NP-11-0016
May 5, 2011

Subject: Exelon Nuclear Texas Holdings, LLC
Victoria County Station Early Site Permit Application
Response to Request for Additional Information Letter No. 07
NRC Docket No. 52-042

Attached are responses to NRC staff questions included in Request for Additional Information (RAI) Letter No. 07, dated April 8, 2011, related to Early Site Permit Application (ESPA), Part 2, Sections 02.04.06, 02.05.02, and 11.02. NRC RAI Letter No. 07 contained twenty Questions. This submittal comprises a partial response to RAI Letter No. 07, and includes responses to the following seven Questions:

Figure 1. Dimensions of East Breaks slump scar. Source of data: NGDC (2008) (Reference 6).

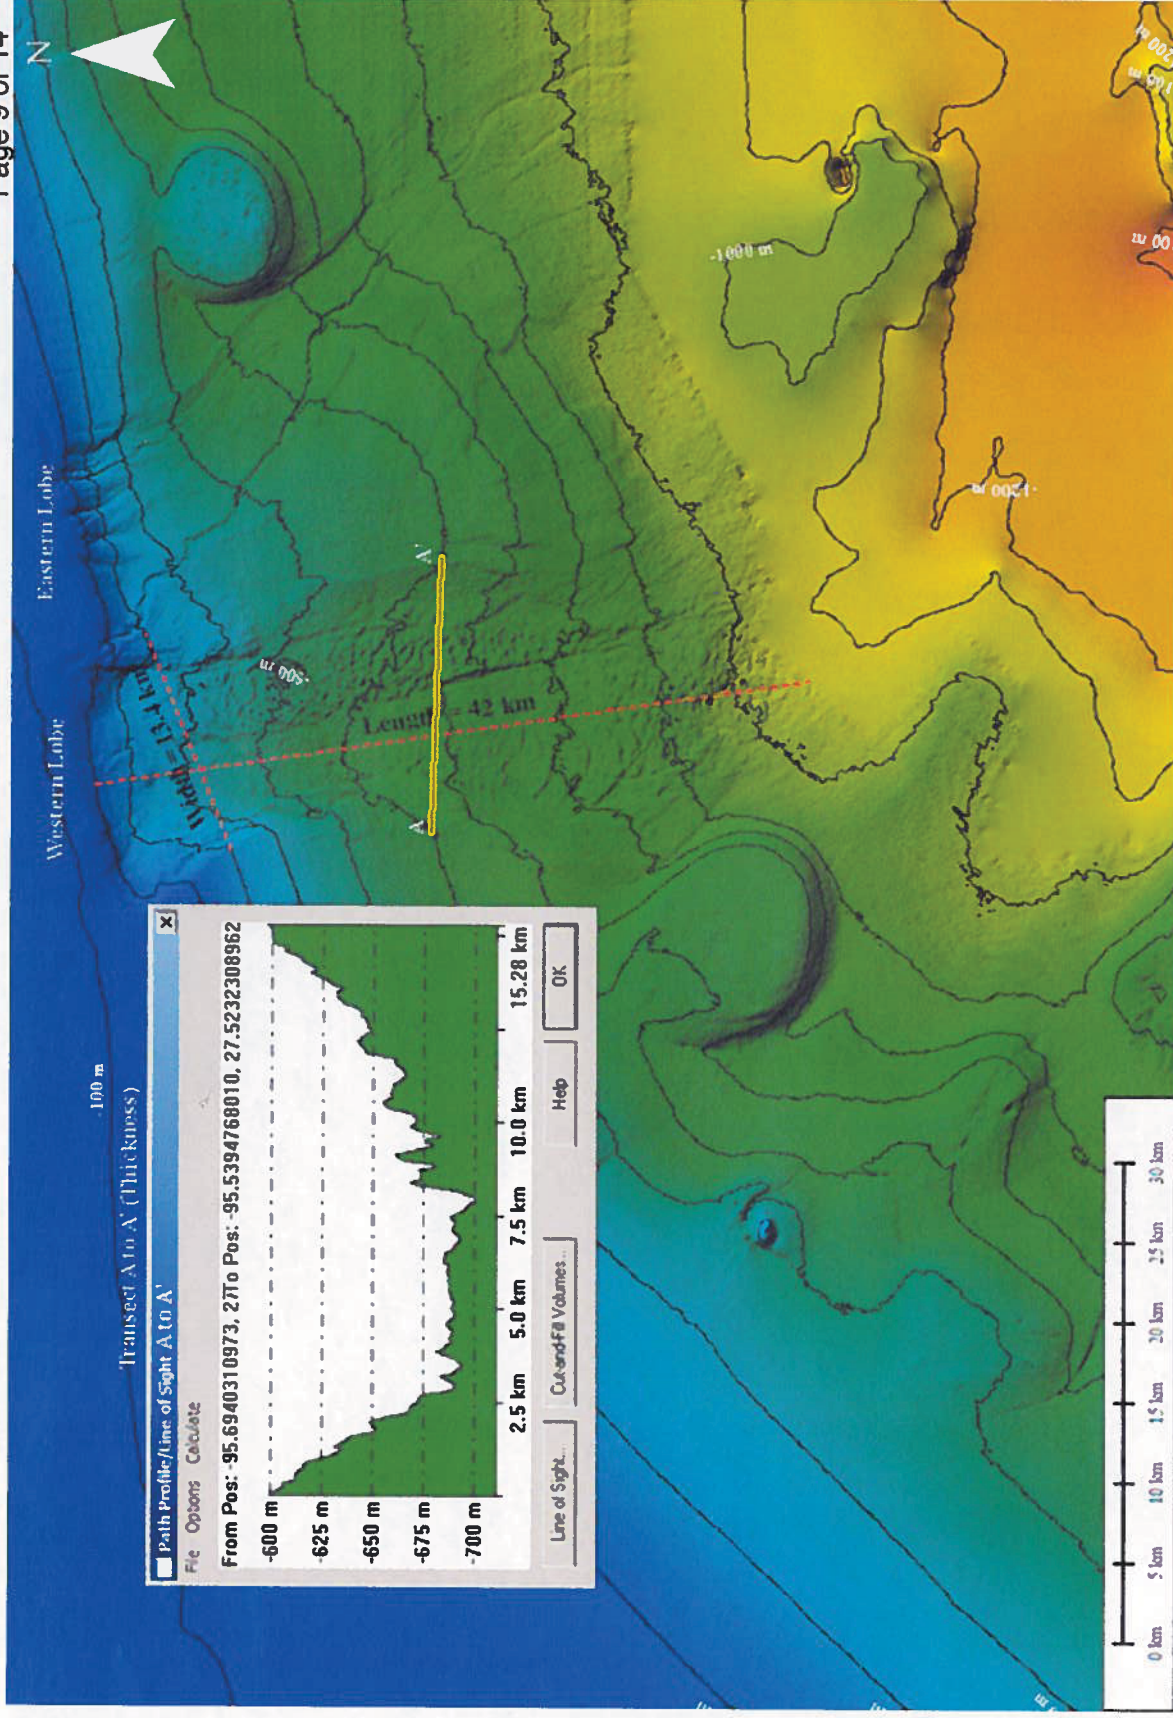
- (6) Updated information, using recently published sources or independent evaluation, on the tsunami source parameters used for the East Breaks slump.

Estimates of dimensions of the East Breaks slump scar have varied with different investigations. For example, source parameters for the East Breaks slump scar are provided in Reference 1. Source parameters for the East Breaks slump were also estimated independently from three-arc-second bathymetry data from the National Geophysical Data Center (NGDC) (Reference 7). Slump width was estimated to be approximately 13.4 km (Figure 1). The length of the erosional chute was estimated to be about 42 km. Based on a transect across the erosional chute, slump thickness was estimated to be about 100 m (i.e., see cross-section profile A to A' in Figure 1). With respect to slope, SSAR Reference 2.4.6-3 stated that "initial failure of the slump took place on very low angle slopes of less than two degrees while present slump deposits have an average seafloor slope of one-degree." While a vertical drop of 850 m over a length of 42 km indicates a bed slope of approximately 1.1 degrees, a maximum local slope of 2 degrees was used as a conservative estimate. Similarly, initial depth of the slide was estimated conservatively at the depth of the midpoint between the 200-m and 1000-m bathymetry contour elevations. Therefore, initial depth was estimated to be 600 m (i.e., $(200 \text{ m} + 1000 \text{ m})/2$). Reference 1, citing interpretation of side-scan sonar data by Reference 8, estimated the length of the East Breaks slump as 114 km. Therefore, the total slide length was assumed to be 114 km.

Figure 1. Comparison of the updated seismicity catalog and the PDE catalog

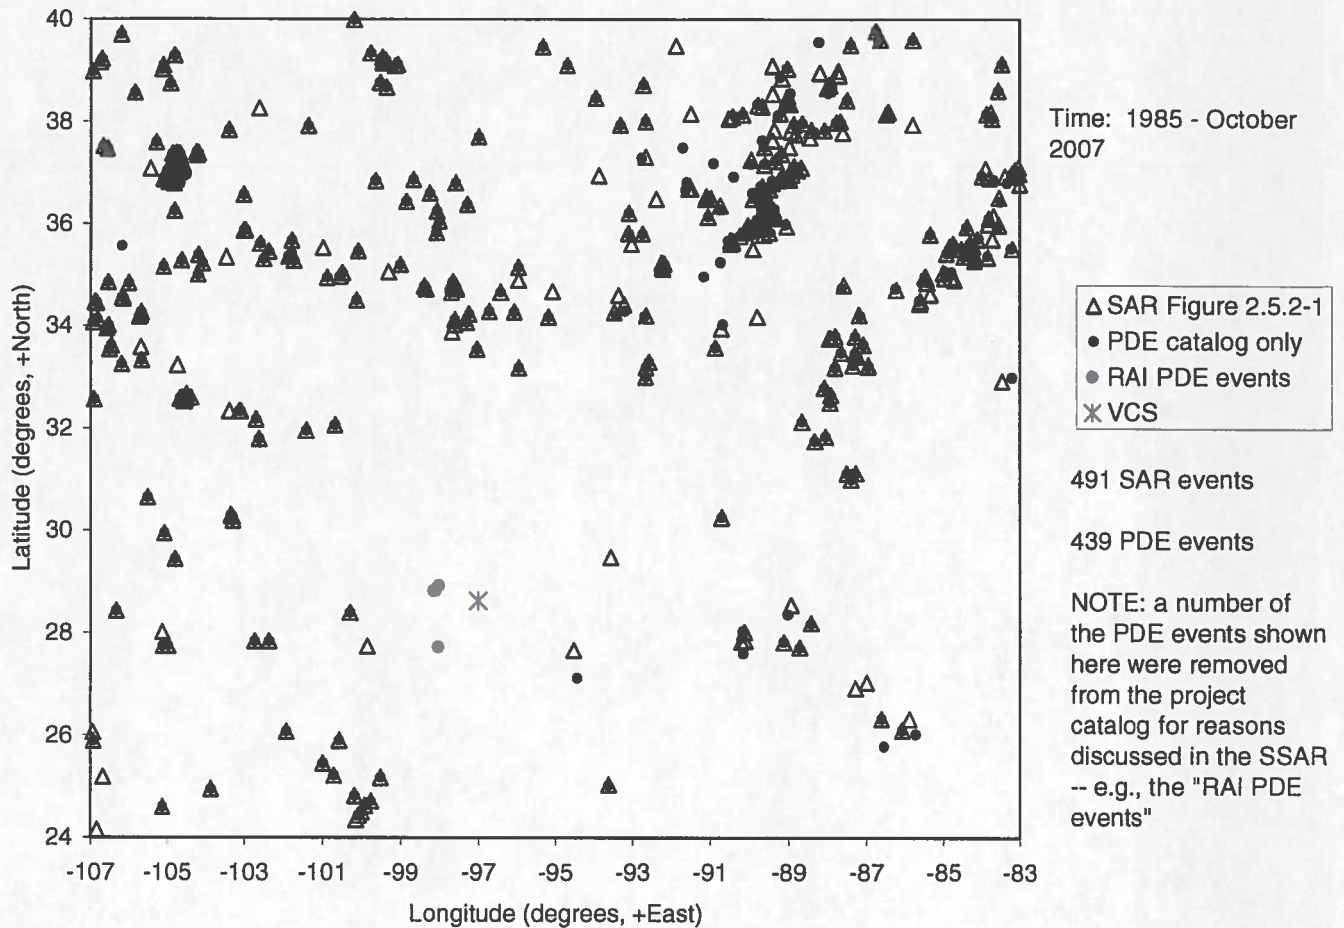
- a) The following four earthquakes are reported by the USGS PDE earthquake catalog and occur within 320-km (200-mi) of the VCS site. These four earthquakes do not appear in the applicant's updated seismicity catalog in SSAR Table 2.5.2-3.

PDE 1991	07202338	19.2	28.91	-98.04	10	3.40LgTUL	3.60LgGS
PDE 1993	04091229	19.1	28.81	-98.12	5		4.30LgGS
PDE 1993	05161530	19.3	28.81	-98.17	5		3.00LgGS
PDE 1997	03242231	134.5	27.72	-98.05	5		3.80LgGS

In addition, SSAR Figure 2.5.2-1 appears to show fewer events than a plot of the PDE events within the same investigation window.

Please discuss these apparent discrepancies between the applicant's updated seismicity catalog and USGS PDE catalog and the impact on hazard at the VCS site.

Exelon considered the four PDE events identified in the RAI during the development of the catalog update. {These events are also listed in other seismicity catalogs considered during the catalog update including ANSS, ISC, and FDNC.} The FDNC seismicity catalog is a catalog of seismic events as referenced to the book, "*Texas Earthquakes*" (Frohlich and Davis, 2002) included as SSAR Reference 2.5.2-4.

Using the PDE (NEIC) catalog obtained to update the seismicity catalog for the SSAR in 2007, and processing the PDE type-specific magnitudes to obtain Emb -- as discussed in the SSAR -- for the same geographic window (83° to 107°W, 24° to 40°N), magnitudes (Emb ≥ 3.0), and primary update period (1985 – 2007), the resulting PDE seismicity is shown in Figure 1, below.) Figure 1 indicates that there are actually more earthquakes in the SSAR Figure 2.5.2-1 (491 events) than given by the PDE catalog alone (439 events) under the search parameters identified above. (Note that only the explicit Gulf of Mexico area (24°N to 32°N, 100°W to 83°W) was updated for all time, as discussed in the SSAR, and six additional pre-1985 events for the Gulf of Mexico area are tabulated in SSAR Table 2.5.2-2.)

As discussed above, it appears that SSAR Figure 2.5.2-1 shows more earthquakes than given by the PDE (NEIC) catalog alone. It is noted that the PDE catalog was considered in the development of the updated seismicity catalog along with several other catalogs that had events not given in the PDE catalog. Based on processing for priority catalogs in the event of multi-source catalog duplication, as well as removing events assessed to be man-made – including the four PDE events highlighted in this RAI, Exelon concludes there is no discrepancy between the PDE and SSAR seismicity catalogs; therefore, there is no impact on the hazard for the VCS site.

Note: The four red PDE events are the events referred to in the RAI, which have been identified as man-made.

Figure 1. Comparison of HF and LF rock spectra for 10^{-4} where the LF spectrum is only anchored to the low frequency ground-motion values. Note that this LF spectrum was not recommended and used in the site response analysis.

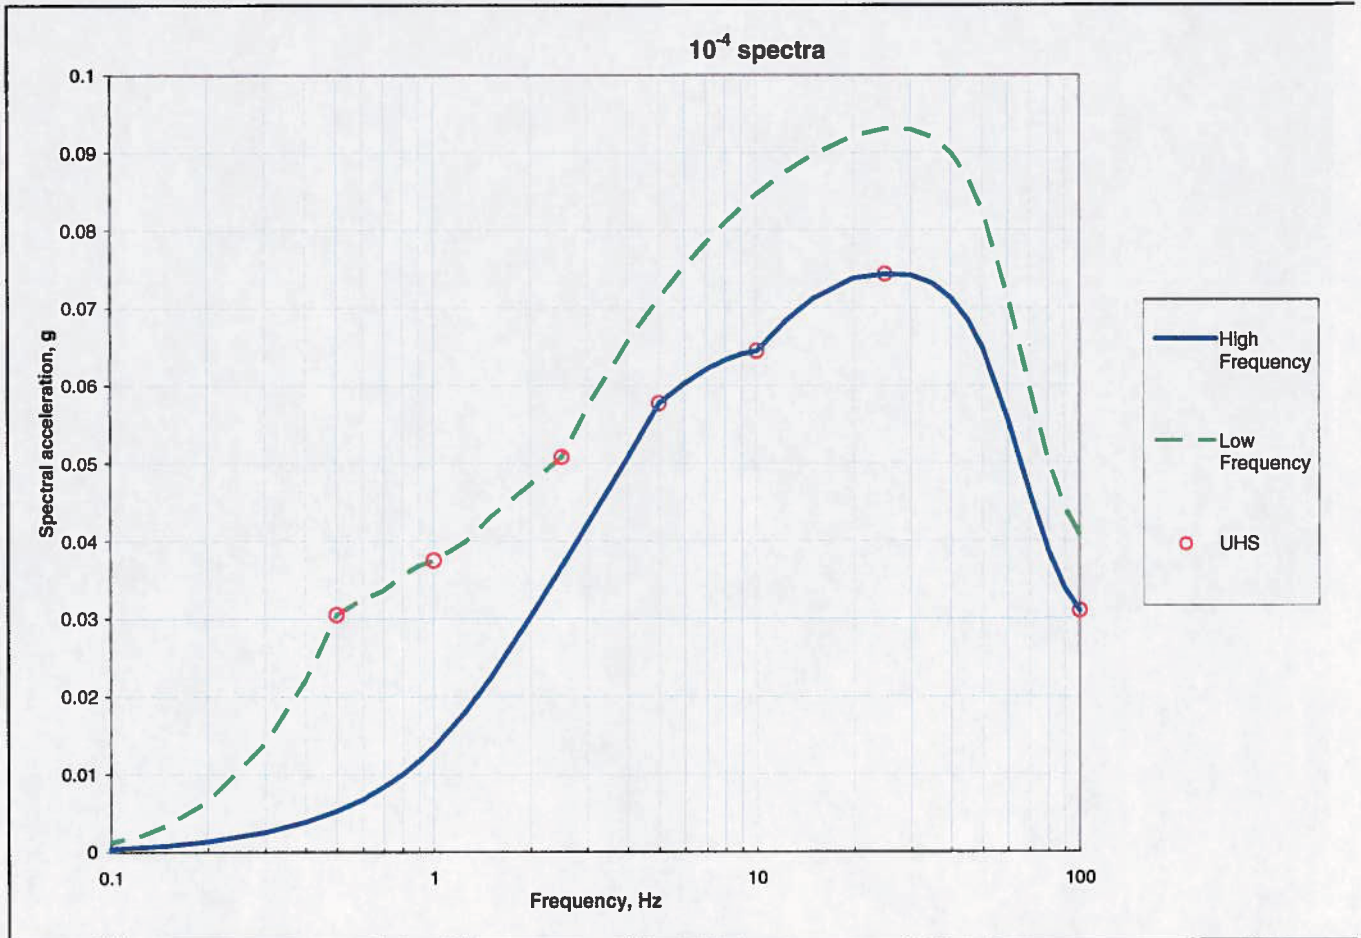
SSAR Section 2.5.2.4.7 describes how the applicant developed its low-frequency (LF) and high-frequency (HF) Uniform Hazard Spectral (UHS) shapes. Please explain the methodology used by the applicant to develop the smooth UHS. In addition, explain why the LF spectrum might exceed the HF spectrum at high frequencies and why this was not allowed.

For the development of the mean LF spectral shapes, the same approach with the anchoring of the LF spectral shapes to the low frequency ground-motion values (i.e., 2.5 Hz, 1 Hz and 0.5 Hz) would lead to associated high frequency ground motions, which would exceed the ground motions from the direct PSHA hazard. This is a consequence of low frequency motions from the hazard being controlled by results with relatively larger ϵ values than the high frequency results. Given the relatively larger ϵ values and the scaling of the median spectral shape anchored to these low frequency ground-motion values, the resulting high frequency motions exceed the hazard at high frequency motions.

The results are shown in Figure 1 for the 10^{-4} mean HF and LF spectral case. The LF spectrum in this figure clearly predicts higher ground motions for the high frequency range between 5 Hz and 100 Hz when the spectrum is only anchored to the low frequency ground-motion values. However, based on the HF and LF rock spectra being used as input ground-motion spectra for the development of site amplification factors (SAF), the LF spectrum was anchored to all of the seven ground-motion frequencies used in the hazard.

Finally, it should be noted that uncritical acceptance of extrapolated LF spectral shape to high frequencies, and the consequent increase of the high frequency part of the spectra beyond UHS values developed from the PSHA analysis could overdrive the soil column during the site response analysis, which could lead to lower site amplification factors.
